STAFF REPORT

THE CORPORATION OF THE TOWN OF COBOURG

| Report No.: | HP-2021-004 | | |

Subject/Title: Roof Replacement – 170 King Street East (Grozier)

Figure 1: 170 King St. E house and roof (Streetview, 2019)

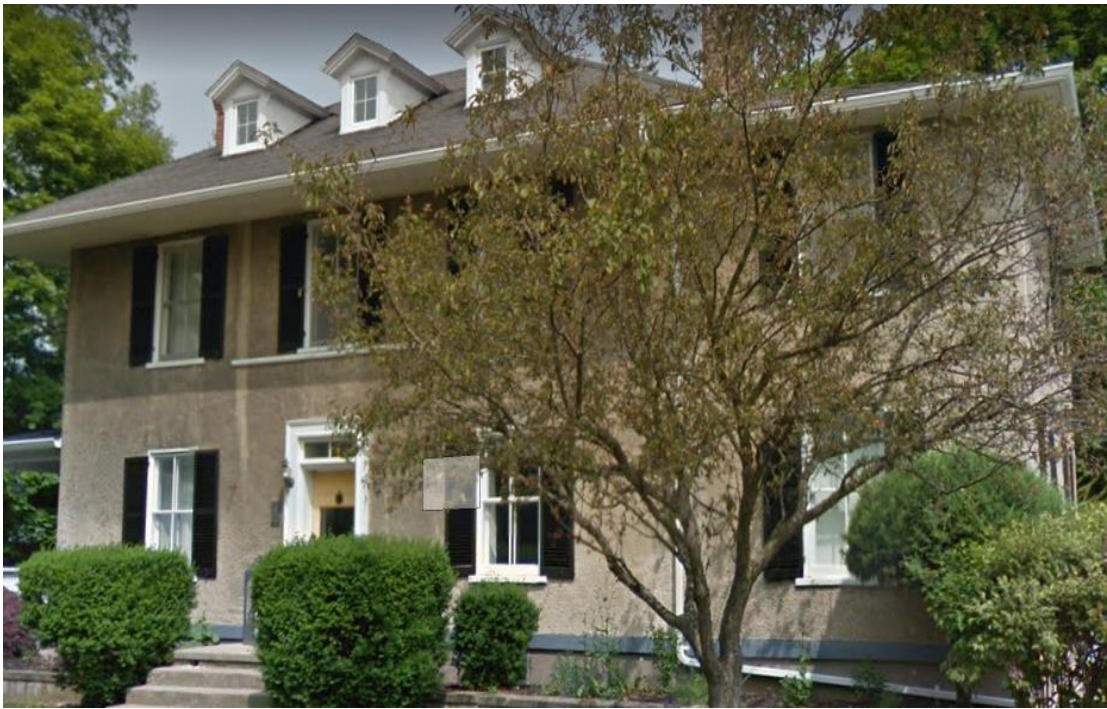
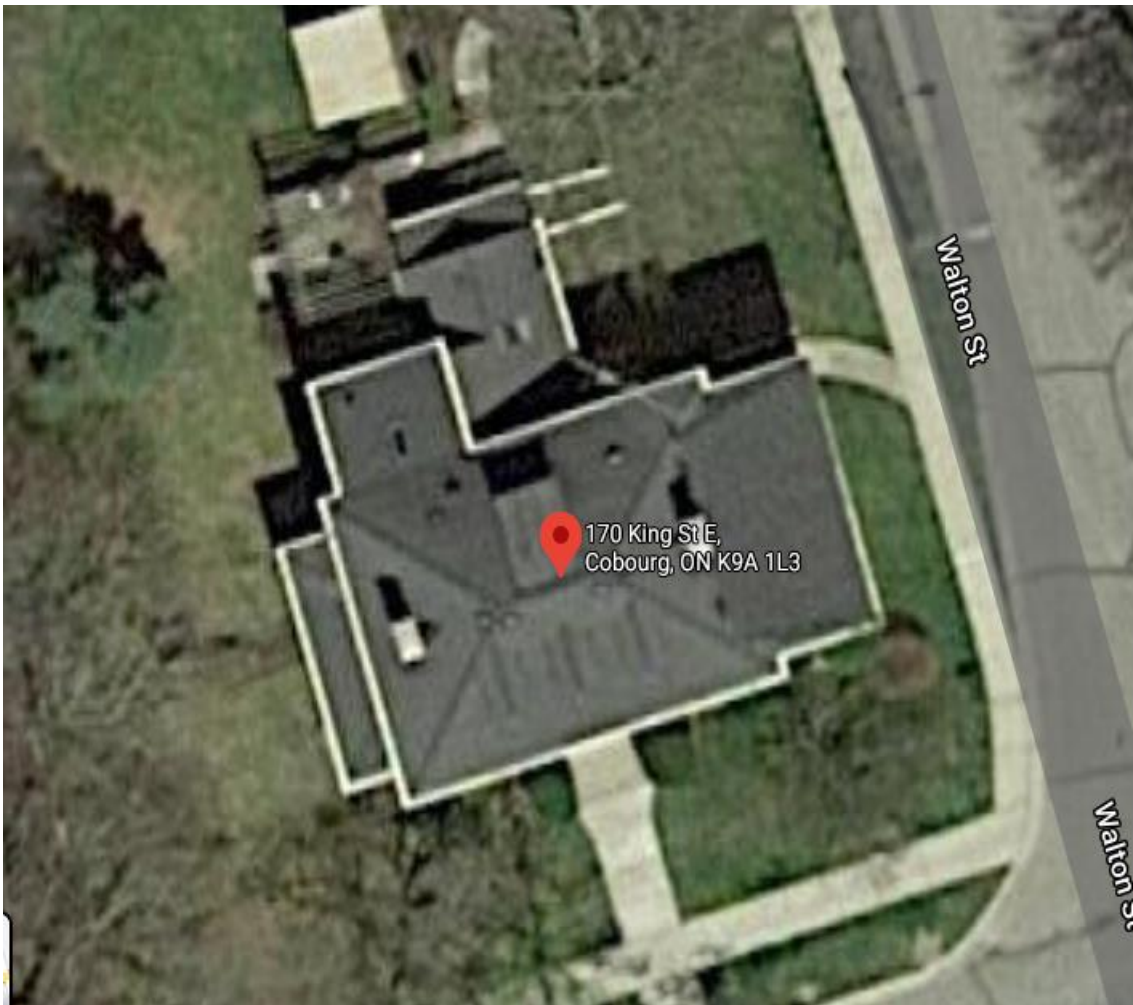
The property owners of 170 King Street East propose to replace the aging asphalt roof with a black metal roof similar in design to other metal roof replacements on commercial buildings on King Street and less so on residential buildings. The owners are proposing metal in order to add a protective element to the roof, more resilient to environmental elements and adding a protective and durable layer for many years to come. The property owner notes that the current roof is ageing. There will also be ultra-low profile vents added to the ridge line.

The proposed alteration has been evaluated against the East HCD Plan, specifically the policy relating to roofs (4.2), and it has been determined that the new roof (change from asphalt to black metal) is an acceptable/sympathetic alteration. The roofline, dormers, chimneys, and other defined heritage attributes are not proposed to be changed as a result of this alteration. The applicants have retained Moffat Bros. as the contractor to undertake the proposed alteration.

FURTHER THAT Heritage Permit Application HP-2021-004, submitted by Ann and James Grozier – be approved to permit a roof replacement at 170 King Street East, subject to the finalization of details by Heritage and Planning staff.
